## SERVICE LETTER No. L 139

**MODEL AFFECTED:** Z 242 L aircraft, S/N: 0787

**SUBJECT:** Aircraft manufacturer instructions for detected cracks and repair instructions.

Fig. No. 2

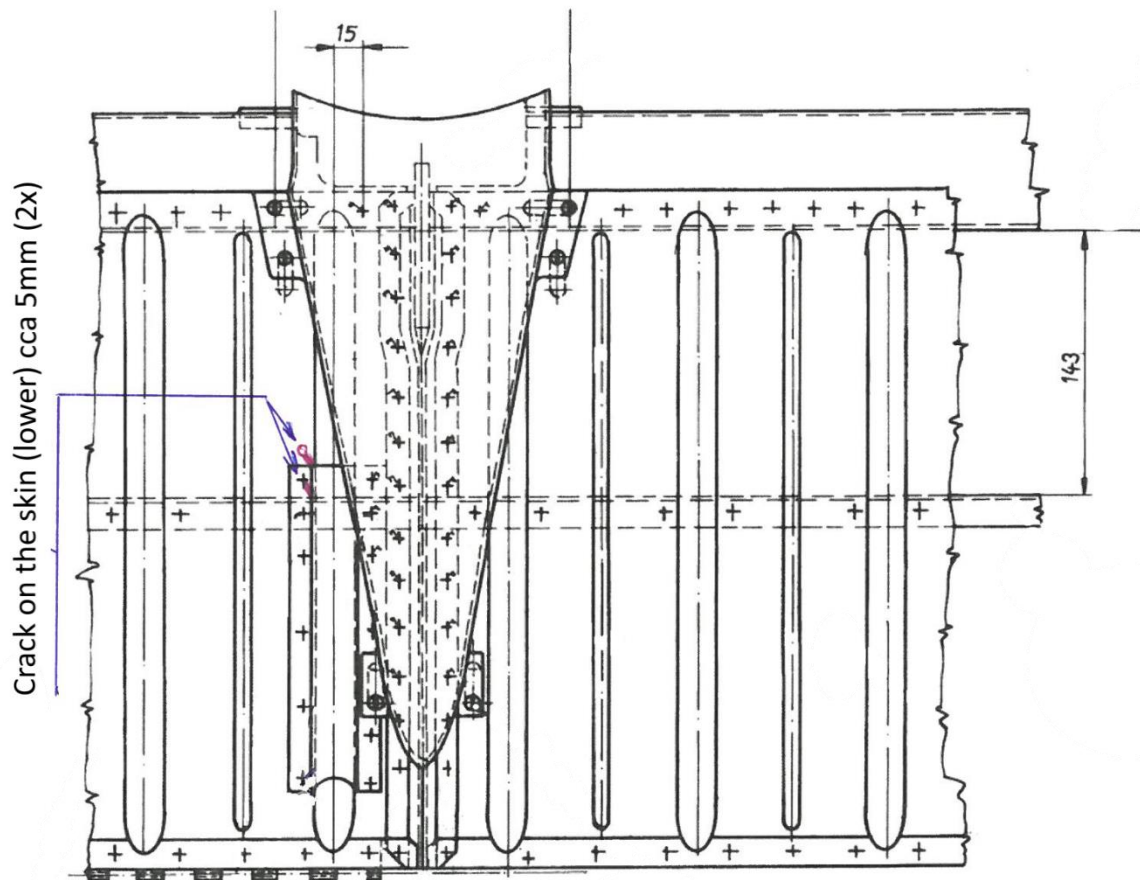
Within the aircraft acceptance after 1500 flight hours inspection the operator reported the cracks disclosed on the lower skin of the elevator. *See Figures No. 1 and No. 2 and No. 3.*

The reported findings were considered by the Commission of Airworthiness and Reliability of ZLIN AIRCRAFT a.s. and its conclusion is that the cracks are repairable with no impact on airplane's airworthiness:

- Remove the existing cover of the trim rod (drawing number L242.3610-08.04A). Drill the hole of 1,5 mm in diameter at the end of each crack in order to stop its propagation. Ream the drilled holes.
- Instead of the removed existing cover install the modified one (drawing number 999-038) which is intended as a repair patch as well. The modified cover is longer by 30 mm compared to the original one. During the installation set the highest point of the cover at the same distance from the trim tab as the original one in order to cover the cracks **and secure free movements of the trim rods.**
- Use the CHERRYMAX CR4523 rivets size 1/8"x 0.260 (approx. 3,2x6 mm) delivered by Zlin Aircraft.
- Note this repair into the Aircraft Log Book.
